MONTGOMERY COUNTY HISTORIC PRESERVATION COMMISSION
STAFF REPORT

Address:	20 West Lenox Street, Chevy Chase	Meeting Date:	1/8/2025
Resource:	Contributing Resource Chevy Chase Village Historic District	Report Date:	12/31/2024
Applicant:	Dan Coughlan (Scott Freedman, Agent)	Public Notice:	12/25/2024
Review:	Historic Area Work Permit	Tax Credit:	n/a
Case Number:	1095563	Staff:	Dan Bruechert
Proposal:	Hardscape Alterations, Installation of In-Ground Pool, and New Fence

Figure 2: The proposed fence is shown outlined in red from the applicant submission. The property boundary is outlined in blue. The existing picket fence is installed partially within the right of way.

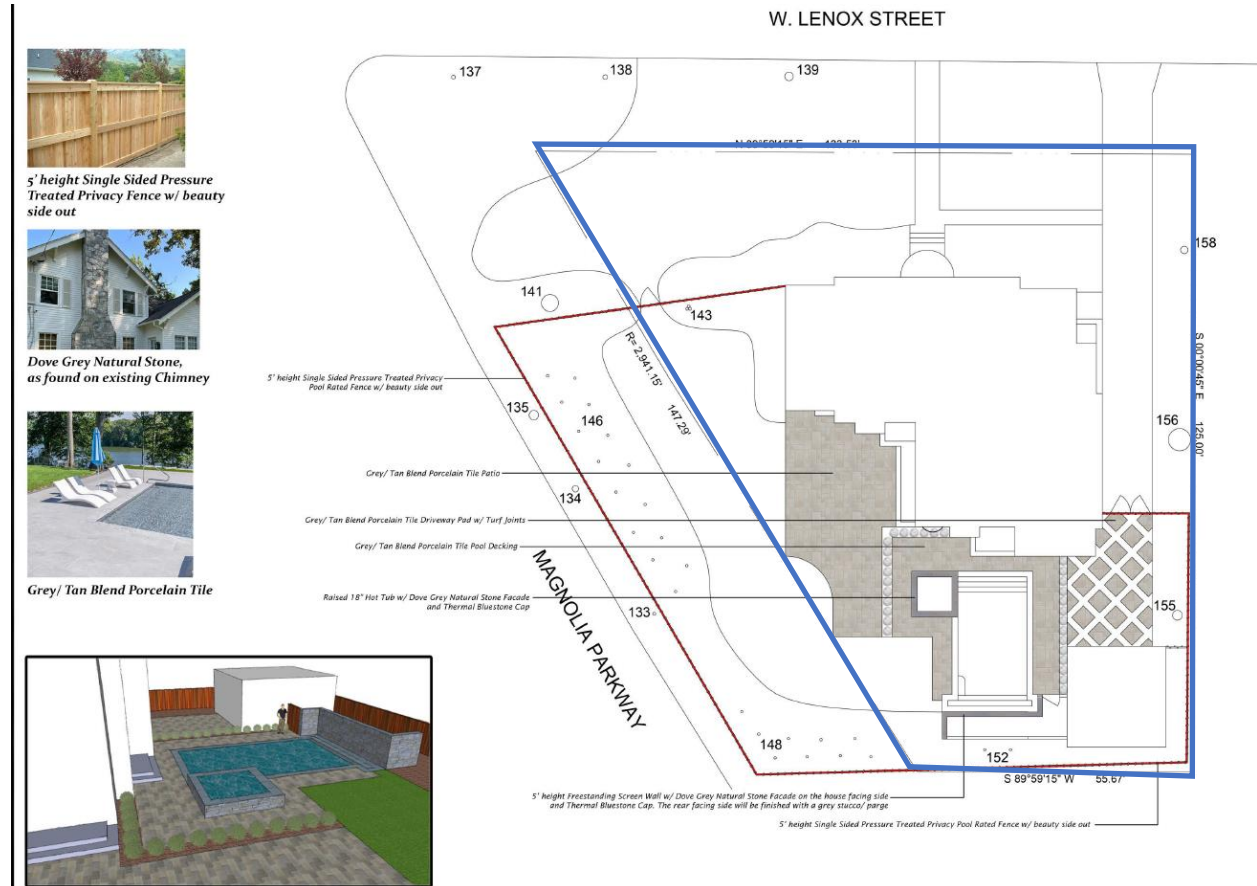
Finally, the applicant proposes to remove the existing painted wood picket fence (between three and four feet tall), that is located partially within the right of way of Magnolia Parkway, and install a 5' (five foot tall) solid board, pressure treated wood fence in its place.

Staff does not find the proposed fence is compatible with the character of the site or surrounding district. The typical requirement for fences in the Chevy Chase Village Historic District is that they be no taller than 48" (forty-eight inches) with an open picket design in front of the historic rear wall plane. Behind the historic rear wall plane, they can be taller and have a solid appearance. However, that requirement does not usually apply to corner lots, such as the subject property. Corner properties are generally held to a more rigorous standards, because their frontage helps to foster the district's open, park-like setting; one of the five basic policies that should be adhered to in the *Guidelines*. Solid fences, especially ones taller than 4' have a tendency to create a wall-like appearance, which is the opposite of an open park like setting. This fact is compounded when the fence is so close to the street. The proposed fence will be 6' 7 1/8" (six feet, seven and one-eighth inch) from the street. Staff does not recommend the HPC approve the proposed fence. The character of this portion of Magnolia Avenue is of particular concern. Staff is unable to find any instances of solid board fencing installed along Magnolia Avenue. All the fences for several blocks are of an open wood picket design. The open parklike character of the district is exemplified by this streetscape, enhanced by the mature tree canopy and open landscaped yards. Using the strict scrutiny

review, staff finds that a solid board fence would be incongruous with the district and this portion of Magnolia Avenue in particular. The proposal would interrupt the open vistas of the properties and appear out of character with the district. A compatible fence should be more transparent and open; such a design can be achieved through utilizing an open picket in a material that would be an incongruous as possible. Additionally, it appears from examining the plans and GIS that the existing fence is installed within the right of way of Magnolia Avenue. Any fence must be installed on the property itself.

Staff would support the applicant installing a 5' (five foot tall) metal fence from the house's front wall plane, provided the fence followed the property line along the western edge. The fence could then continue along the rear property line. Staff finds that a dark colored metal fence would be less visible than a larger wood fence and the dark color would recede into the background, again, reinforcing the district's open park-like setting. Additionally, requiring the fence to stay within the boundaries of the property and not into the right-of-way will better preserve the character of the streetscape. Staff is recommending approval of the HAWP under 24A-8(b)(2) and (d), the *Design Guidelines*, and *Standard 2 and 10* with the proposed conditions to modify the fence.

1. The applicant must install a 5' (five foot tall) dark metal fence that may not extend further west than the property line and may not project into the right-of-way;
2. Dimensions of the proposed patio must be provided on all plan sheets;

DRAWING TITLE:
Design Layout
and Cover Sheet
Page 1 of 4

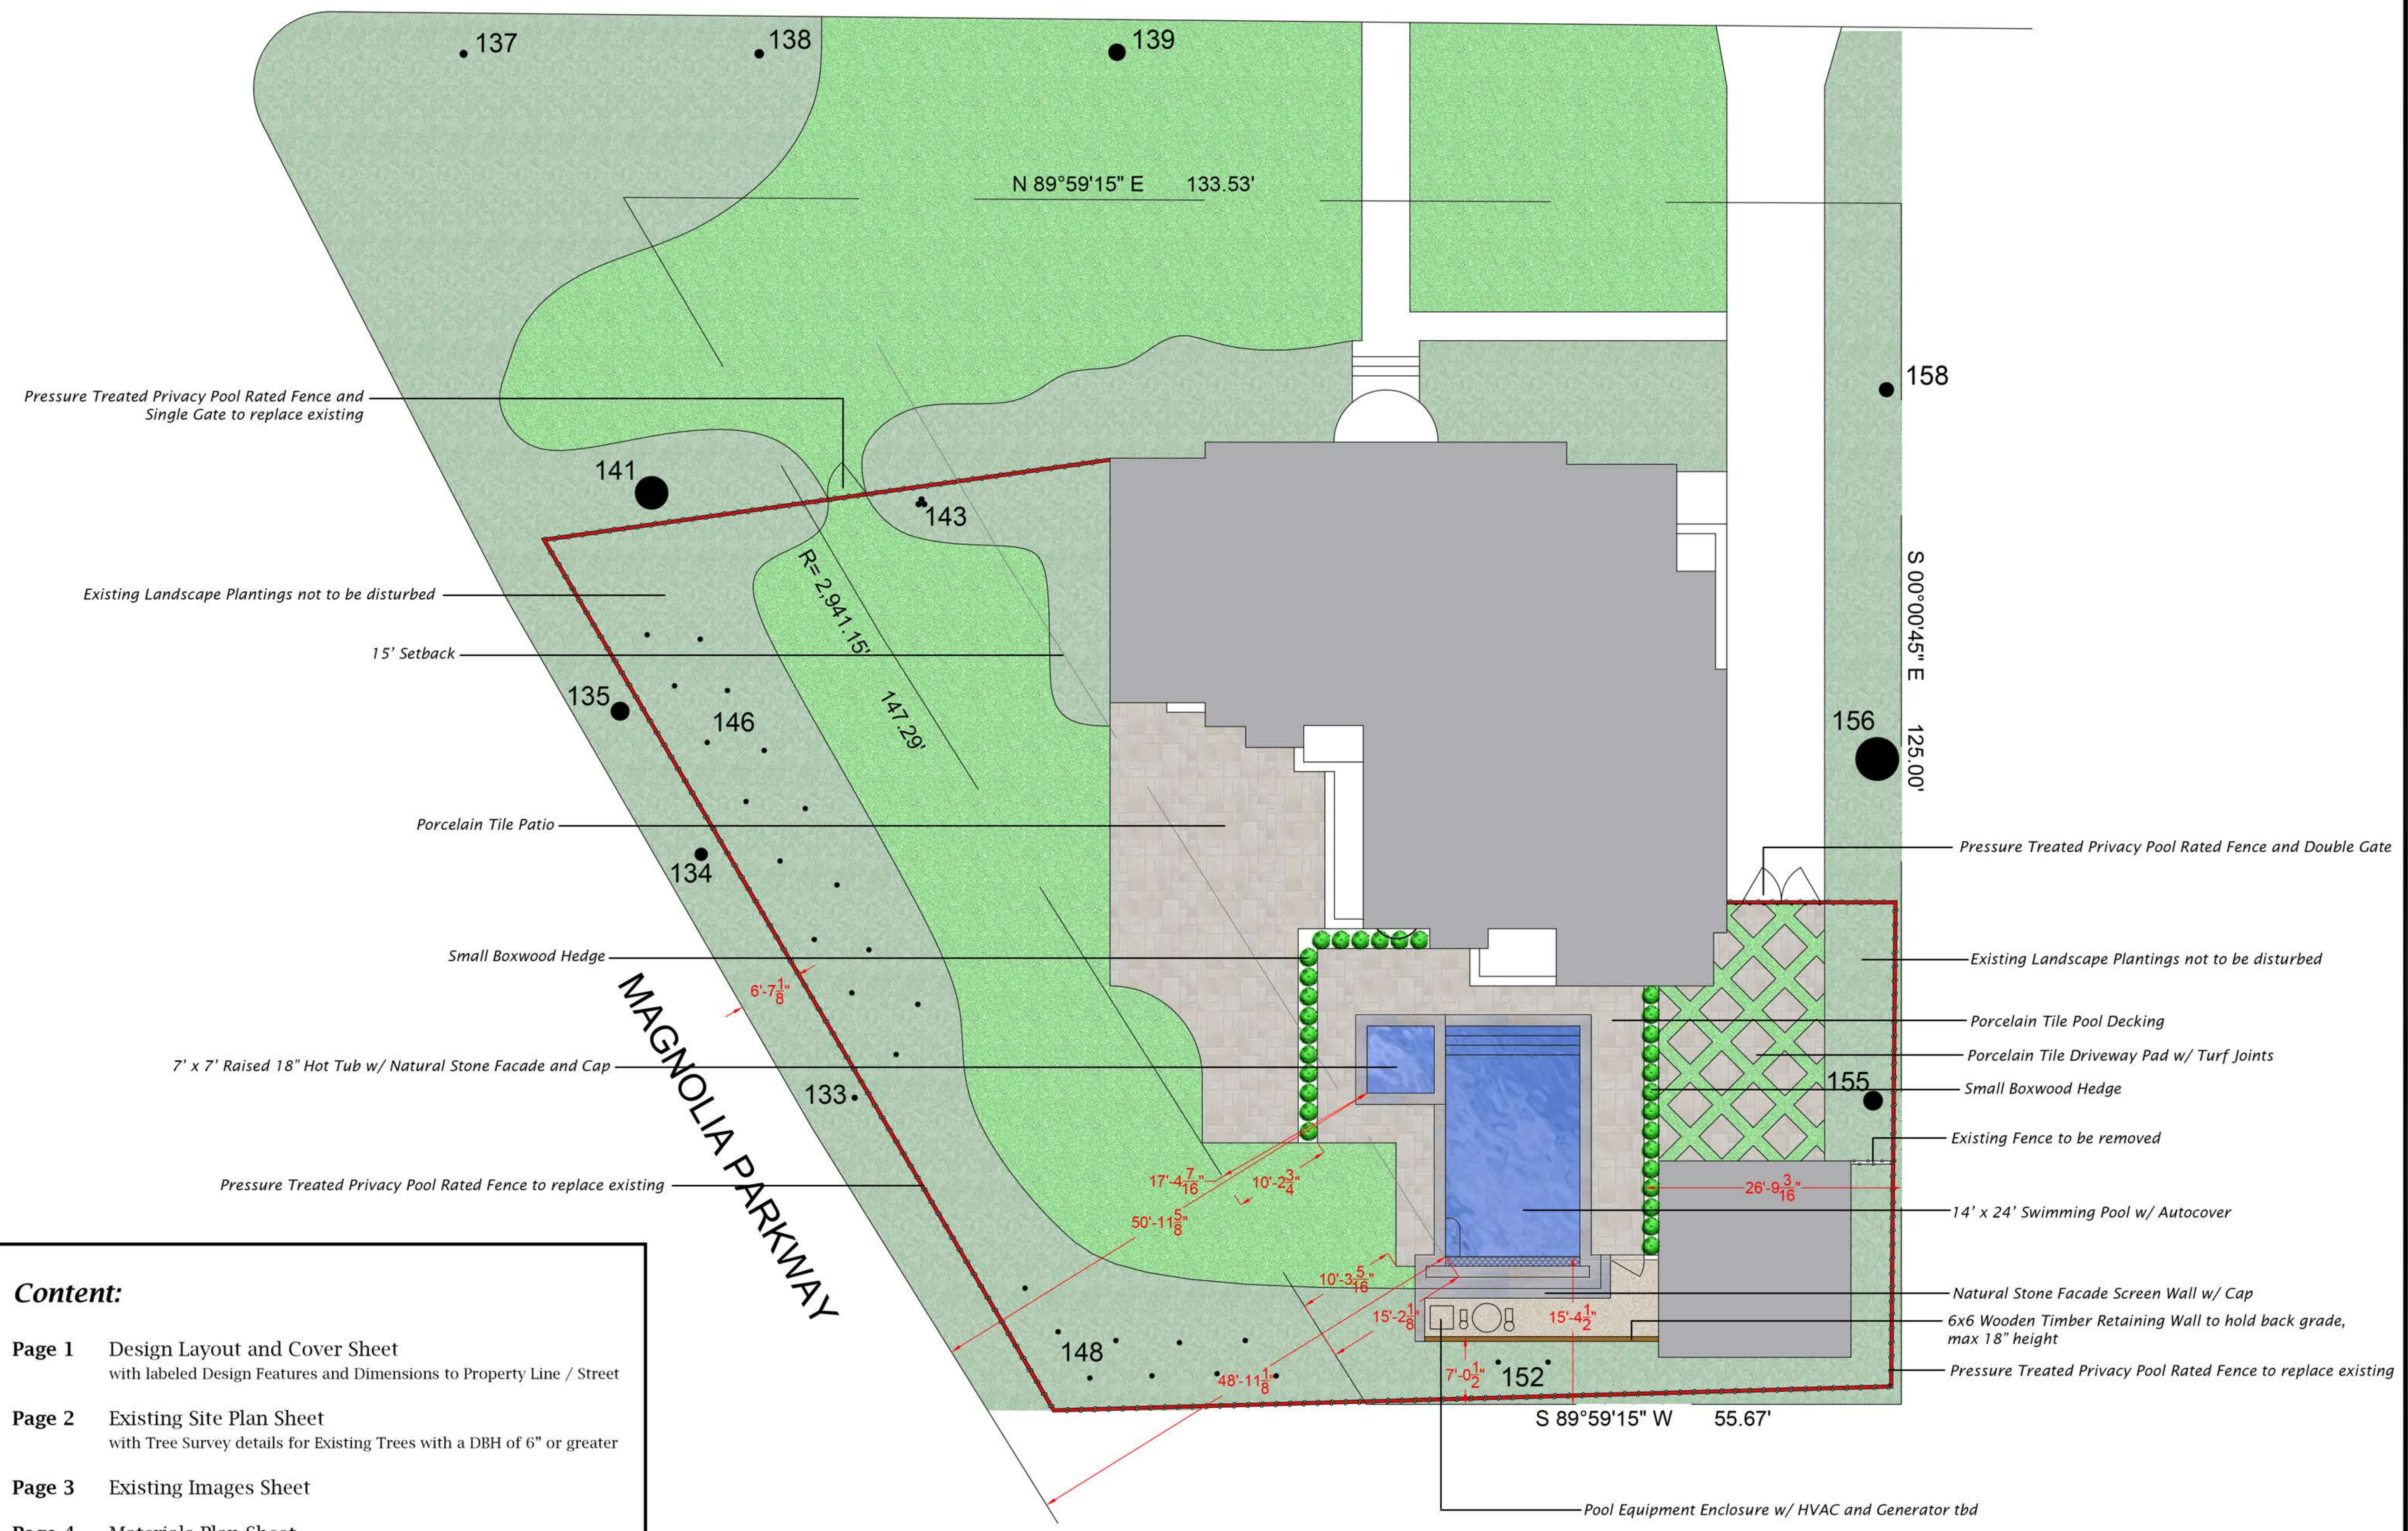
Dimensions of the existing and proposed patio were not identified in the submitted materials, however, Staff finds that the proposed patio will not overwhelm the character of this very large yard. All of the patio is to the east of the west wall plan and, as this will be installed on grade, will not substantially change the visual character of the site and surrounding district. Staff recommends the HPC approve the patio under 24A-8(b)(2) and (d) and *Standard 2*.

DRAWING TITLE:
Materials Plan

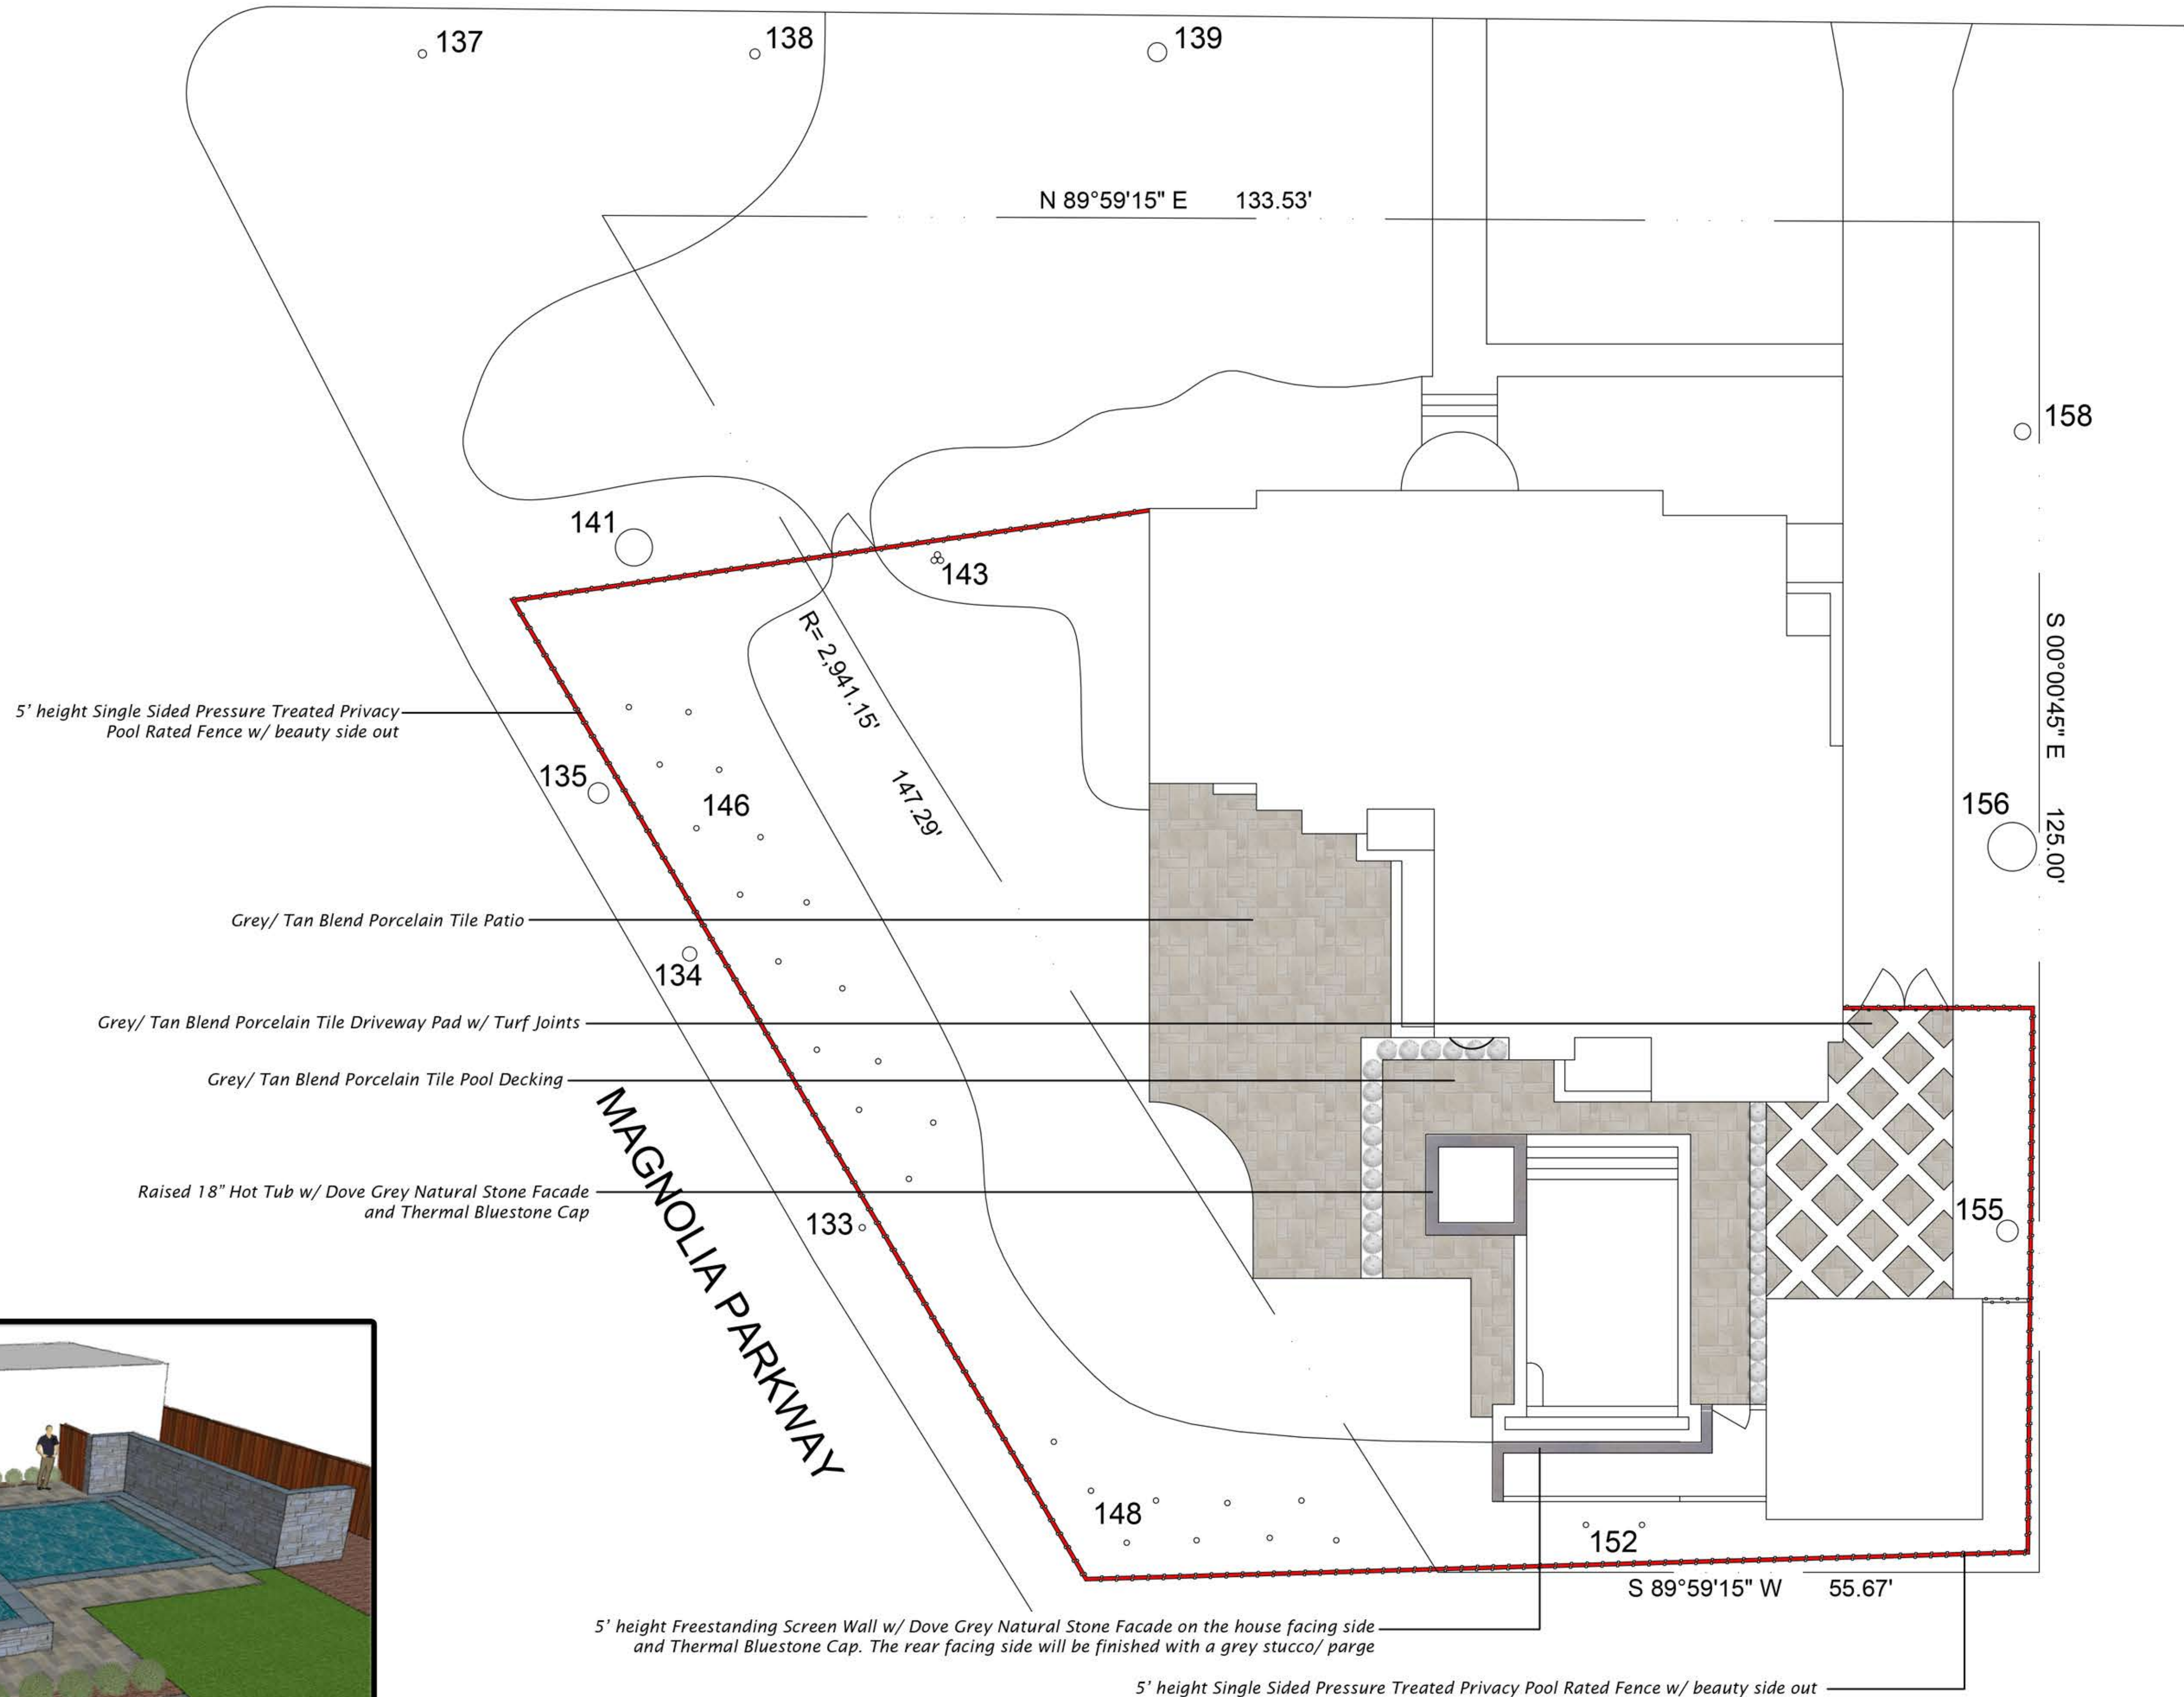
5' height Single Sided Pressure Treated Privacy Fence w/ beauty side out
